**PLANNED UNIT DEVELOPMENT
& SUBDIVISION STAFF REPORT****Date: October 2, 2008****DEVELOPMENT NAME**

Providence Park POB West Subdivision, Resubdivision of Lot 1, Resubdivision of and Addition to Lot 1, Phase II

Planned Unit Development Approval to amend a previously approved Planned Unit Development master plan for Providence Park to allow a cancer treatment facility, and Subdivision approval to create 2 lots.

SITE PLAN

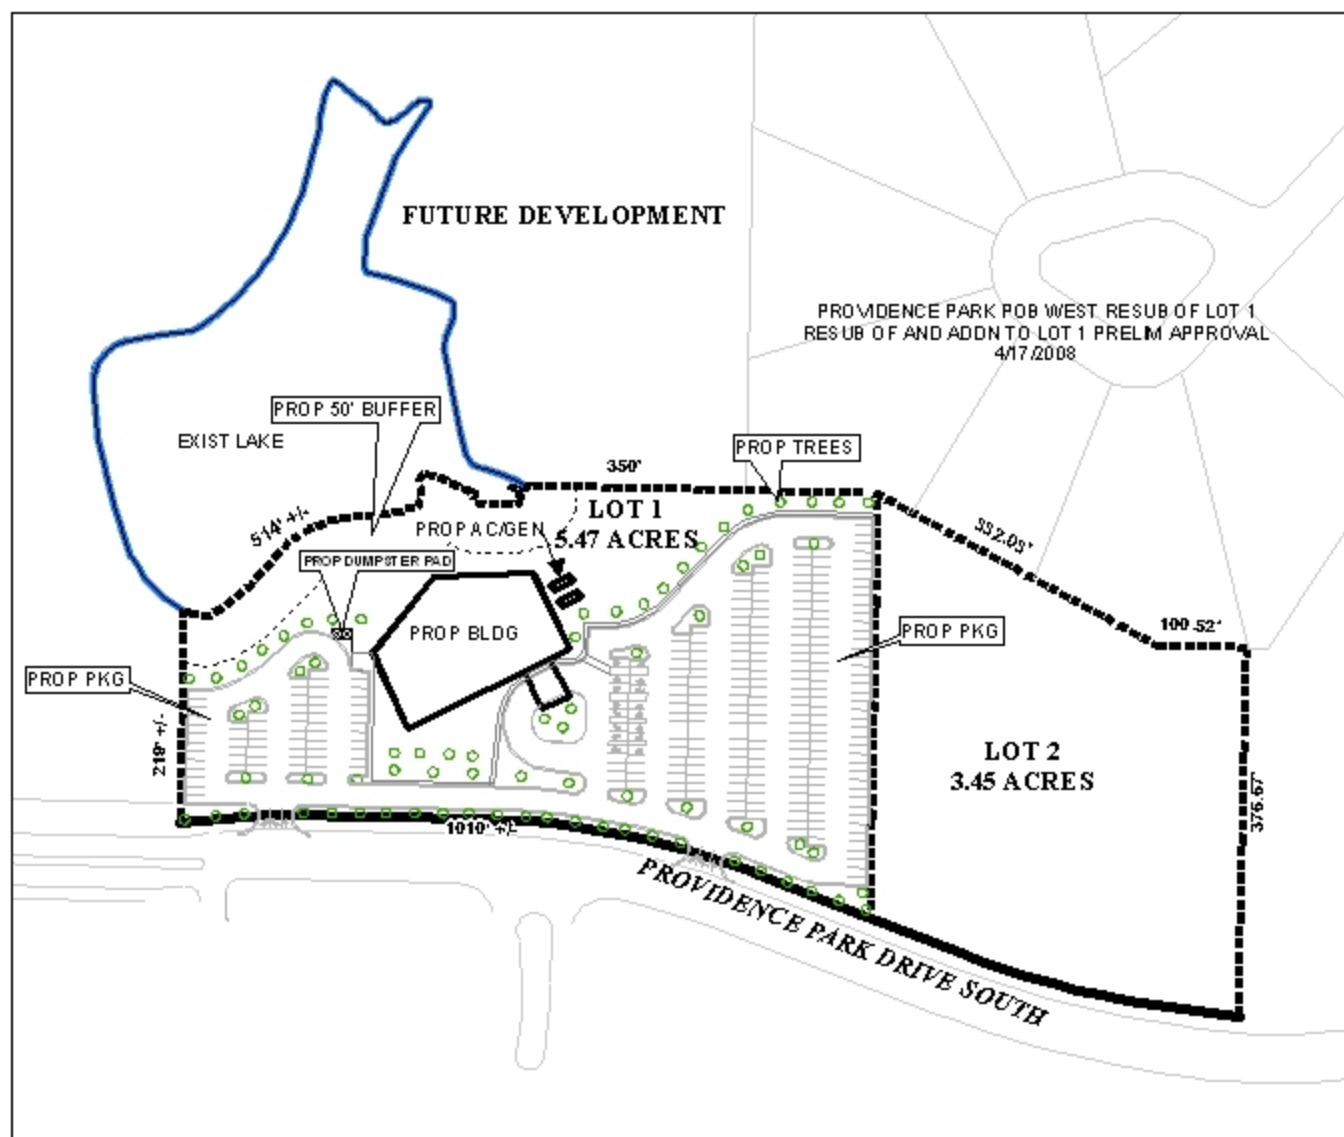
The overall PUD site plan shows the entire hospital development, however, several errors are evident. The “proposed” Bonefish Grill and Hampton Inn are now in operation, thus their labels should be revised. The overall site plan should also be revised to clearly delineate and label the public versus private portions of Providence Park Drive and any other private streets.

The proposed 60,000 square foot cancer center will require 200 parking spaces: 290 parking spaces are depicted on the site plan, however, the data on the plan states that 293 spaces are provided. It should be pointed out that such a facility will generate waste, and there do not appear to be any provisions for dumpster or other service entrances for the building. Furthermore, there is no indication of any free-standing HVAC or generator systems, which such a building would likely have. The site plan should be revised to show the correct number of parking spaces, any proposed dumpster areas or service drives, and any proposed locations (generally) of free-standing HVAC or generator systems.

It should also be pointed out that no information is provided regarding the compliance of the site as it relates to the tree requirements of the Zoning Ordinance. It appears, however, that there will be adequate area for the required tree planting. The site plan for the cancer center should be revised to show compliance with the tree requirements (frontage, perimeter and parking) of the Zoning Ordinance.

As a site design note, the site plan depicts 16 handicap parking spaces with no sidewalk access to the main entrance. Persons parking in the handicap spaces will be required to cross traffic to enter the building. No pedestrian circulation is depicted on the site plan, nor are any sidewalks shown along Providence Park Drive: sidewalks will be required along the public street.

The site plan does not indicate curb-cuts which exist across from the site, particularly the entrance into Providence Estates, and the small office building. As changes to the location of curb-cuts affects site design and Traffic Engineering decisions, the location of the curb-cuts across Providence Park Drive from the site should be indicated.

Finally, the dimension labels for the Western portion of parking area depicted the detail site plan for the cancer center site incorrectly show the width of parking stalls and access drives. The site plan should be revised to correctly show the 24-foot width of the access drive, and the 19-foot length of the parking stall.

- 1) Revision of the overall PUD site plan to show what is existing versus what is proposed (examples of Bonefish Grill and Hampton Inn);
- 2) Revision of the overall PUD site plan to clearly delineate and label all public and private streets;

- 3) Revision of the site plan to show compliance with the tree planting requirements of the Zoning Ordinance for the cancer center site.
- 4) Revision of the site plan to show any proposed service drives, dumpster locations, or freestanding HVAC or generator locations;

- 5) Revision of the site plan to depict existing curb-cuts across the street from the site;
- 6) Revision of the site plan information to correctly total the number of parking spaces;

- 7) Revision of the site plan to depict a sidewalk along Providence Park Drive, or submission of a sidewalk waiver application;
- 8) Compliance with Engineering comments (*Must comply with all storm water and flood control ordinances. Any work performed in the right of way will require a right of way permit. Must provide detention for any impervious area added since 1984 in excess of 4,000 square feet. Need to verify that the detention pond has sufficient capacity and is functioning properly.*);

- 1) Revision of the site plan to show correct compliance with the tree planting requirements of the Zoning Ordinance for the cancer center site;
- 2) Revision of the site plan to label the depicted dumpster locations;
